# Central Coast Quarter Stage 1 Modification 7

State Significant Modification Assessment Report (SSD-23588910-Mod-7)

October 2025

**Figure 4** | approved vehicle access to future stage (Ground floor)

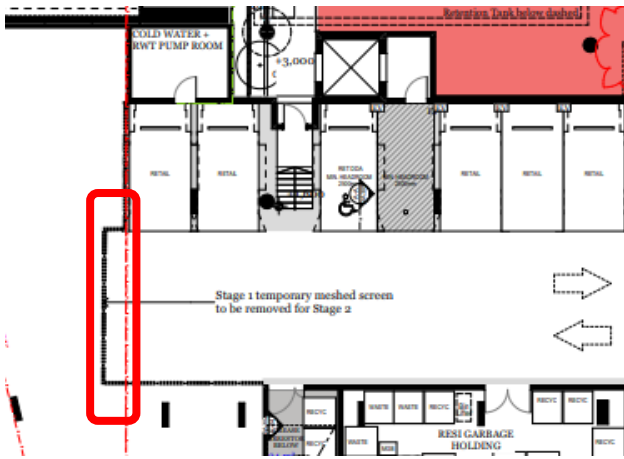
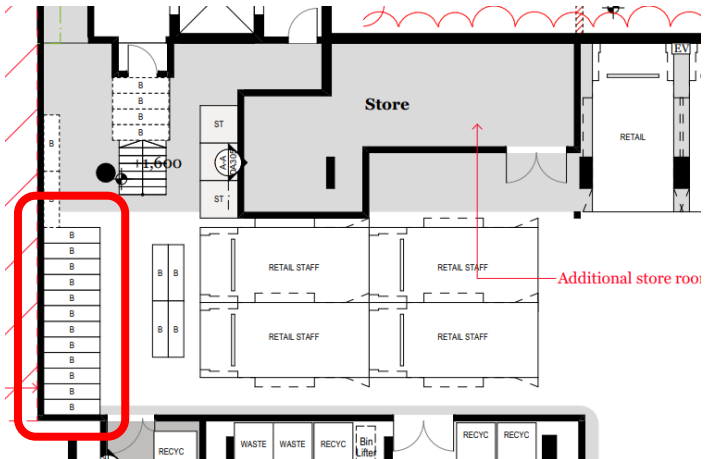
Concerns were raised by CoGDAP regarding the proposed removal of access between the approved stage 1 and future stage 2 ground level basements as shown in **Figure 4** and **Figure 5**. CoGDAP noted that the removal of vehicle access between the two ground level basements would have an impact on traffic volumes and access onto Baker Street and its public domain and that the proposed amendments would result in potential impacts for the wider street network in terms of vehicle movements. It was also noted that the concept plan has approved the entries connected across stage 1 and 2 basements.

CoGDAP recommended that the proposed removal of access between stage 1 and 2 basements be validated by an updated traffic and access impact assessment, to ensure that the proposed removal of access between the two basements does not result in adverse impacts on Baker Street and its public domain.

The concerns raised by CoGDAP on the removal of access between stage 1 and 2 basements are noted however, the access between the two basements was intended to provide thoroughfare for the occupants between the two buildings. The dual accessway between stages 1 and 2 basements was not a design feature that was included with the intention to reduce traffic on Baker Street or the surrounding street network.

The Department notes that entrance to the future stage 2 development is provided separately, off Baker Street, which has been considered in the traffic impact assessment for the concept approval. The second vehicular entry into the future stage 2 development has been presented in the concept approval and stage 1 architectural drawings, which clearly indicates that there are two separate entry/exit points for stage 1 and 2 off Baker Street. As such, the Department considers that an

updated traffic study assessing the potential traffic and access impacts on Baker Street and its public domain is not required. The Department is satisfied that the proposed removal of access within stage 1 and future stage 2 basements will not have any adverse impacts on Baker Street or any other surrounding road network. The occupants of future stage 2 will be able to access the development through a previously approved 'vehicular entry 2' point, along Baker Street, which has been considered in the traffic and access impact assessment that informed the concept approval.

**Figure 6** | approved bicycle storage facility (ground floor)

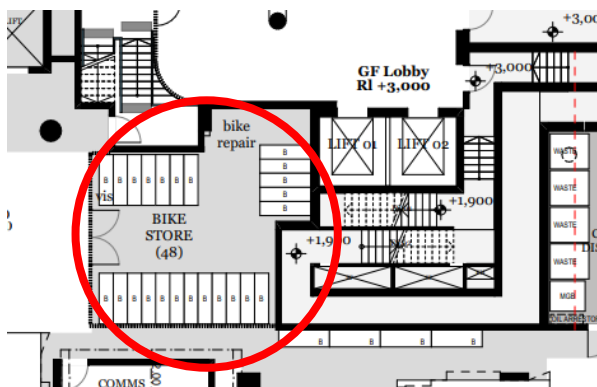
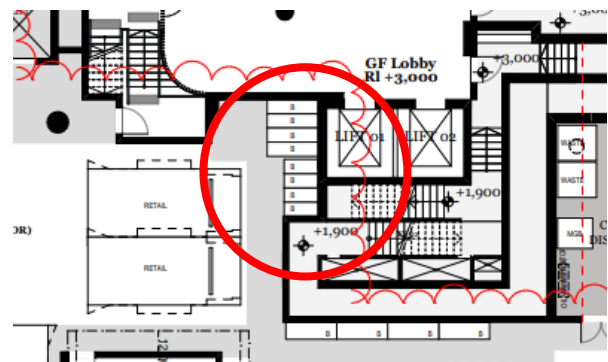
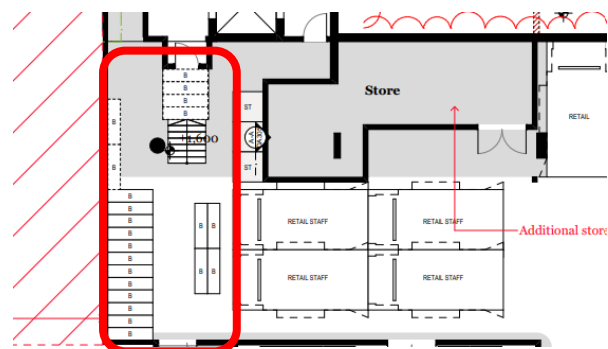
The proposed modification includes amendments to bicycle parking from an enclosed and lockable room in close proximity to the end of trip facility and lifts, to an open area along the western edge of the ground floor. The Department is concerned that the proposed arrangement would result in a disincentive to use the bicycle parking.

The applicant confirmed that the proposed bicycle parking arrangements will retain full compliance with the required bicycle parking rates under the applicable planning controls. The number of bicycle parking spaces is retained and continues to meet the relevant requirements.

The Department acknowledges the applicant's response and notes that the proposal continues to achieve full compliance with the applicable bicycle parking rates under the Gosford City Centre Development Control Plan 2018. While the configuration differs from the originally endorsed arrangement, the number of spaces remains consistent with statutory requirements and remain in a secure, weather protected and accessible location. On this basis, the Department considers the amended bicycle parking provision acceptable.

**Figure 13** | approved visitor DDA parking space location

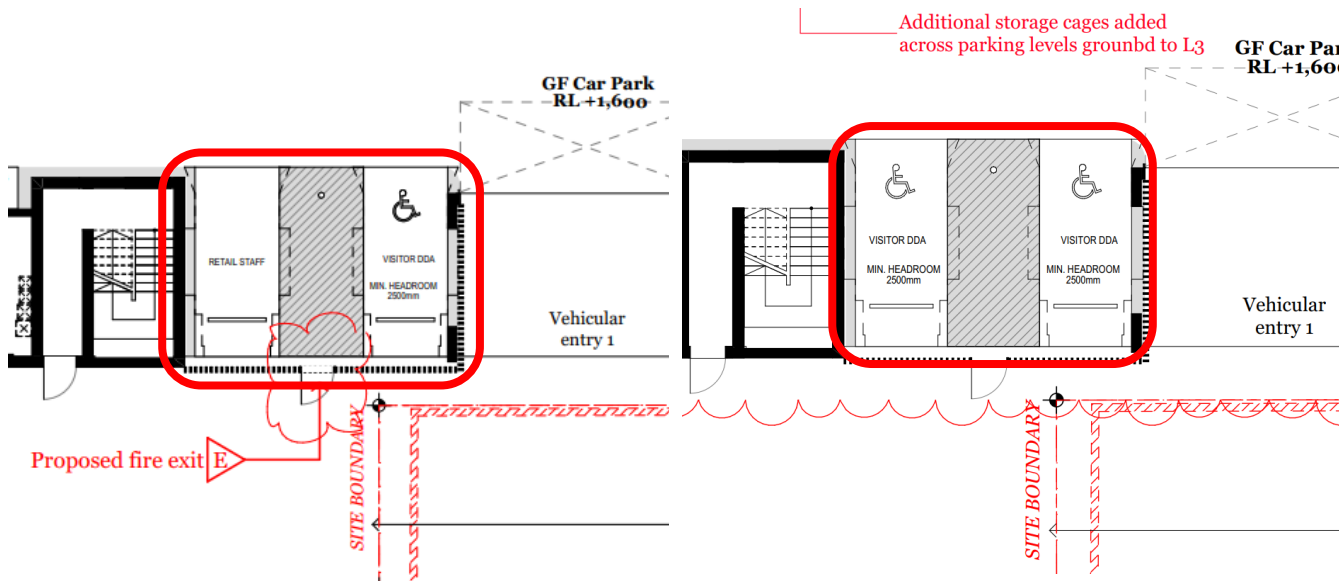
- the potential traffic impacts on Baker Street as a result of removing the vehicle connection between the Northern Tower basement and the future Stage 2 basement
- the relocation accessible parking at the ground floor basement (**Figure 13** and **Figure 14**)
- the proposed bin hoist arrangement between the shared Stage 1 & 2 garbage storage and bin pick-up areas
- the removal of bike parking in a lockable room and relocation of bike parking in different areas at the ground level.

The modification proposes to relocate one accessible visitor ground level parking space on the western side of an existing approved accessible visitor parking space, adjacent to the vehicle entry and vehicle access ramp. The Department raised concerns that the accessible visitor parking space will be further from the lifts, and its new location could potentially cause conflict between pedestrians and vehicles due to its proximity to the vehicle ramp entry/exit.

The applicant noted that the proposed relocation of the accessible visitor space had been reviewed by the project's access consultant, who confirmed that the proposed location of the accessible visitor parking space is acceptable as a compliant and suitable path of travel to the lifts is maintained throughout the ground floor basement, directly to the lifts. The applicant also noted that the accessible spaces have been designed in accordance with AS/NZS 2890.6-2009 and will maintain compliance with the Disability (Access to Premises – Buildings) Standards 2020, the Accessibility Provisions of the Building Code of Australia (BCA), and AS 4299 Adaptable Housing. A letter from the project's access consultant Jensen Hughes confirming the suitability of the proposed accessible parking space is appended to the applicant's response to RFI.

The Department has considered the proposed relocation and potential impacts of one accessible visitor parking space to the western side of an already approved (under Modification 3) accessible visitor parking space, adjacent to the vehicle entry and vehicle access ramp. Whilst the proposed location of the parking space is somewhat further from the lifts in the approved design, a clear path of travel to the lifts is maintained from the new location. Pedestrians can travel directly west to the lifts, which will not directly interfere with vehicles entering and exiting the basement.

The Department considers the proposed relocation of the accessible visitor parking space is acceptable as it allocates the two accessible visitor spaces to the same designated space. The Department is satisfied that the proposed relocation of the accessible visitor parking space complies with all applicable statutory and technical standards, delivering safe, inclusive and accessible outcomes for all future users, including people with mobility needs. The proposed relocation of the parking space will not result in a net loss or gain of the approved parking space targets.

**Figure 15** | proposed opening area for future stage 2 bin hoist

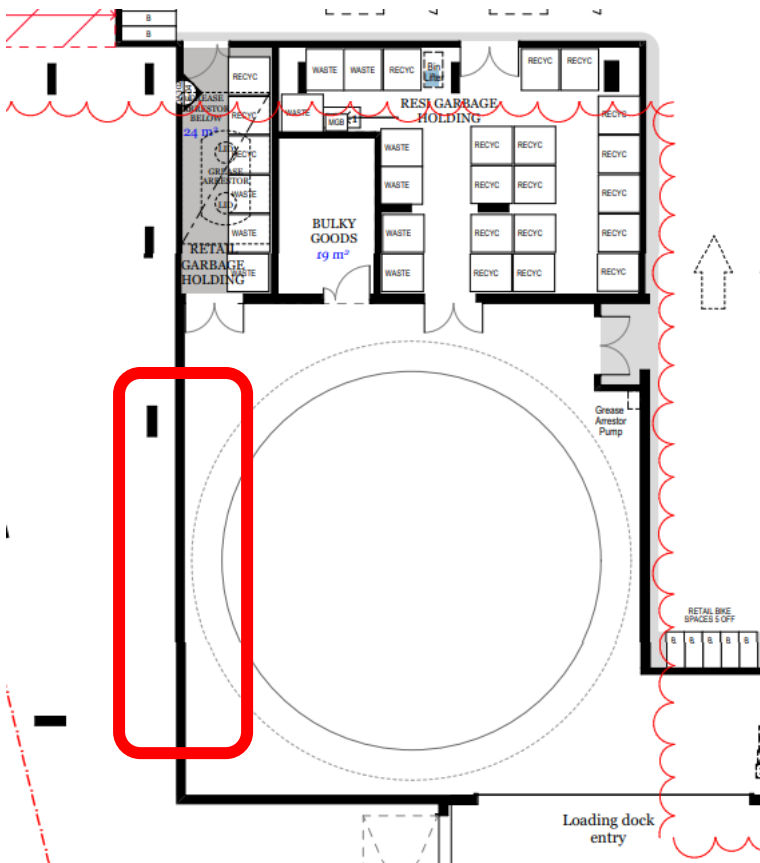
The Department requested additional information on the proposed bin hoist, including its location and how it will operate spatially.

The applicant confirmed that the future stage 2 development will include a designated holding area for bins. A bin hoist will be provided next to the designated bin area and will operate between the basement levels beside the existing stage 1 loading dock, so that bins from stage 2 are able to be moved into the designated bin area in stage 1 (see **Figure 15**).

The Department has considered the proposed future bin hoist and opening within the waste storage area and is satisfied that it allows for an appropriate waste management solution for the future stage 2 development. The proposed future opening will be able to allow for the efficient transfer of waste from the future stage 2, while maintaining safety and functionality within the basement environment.
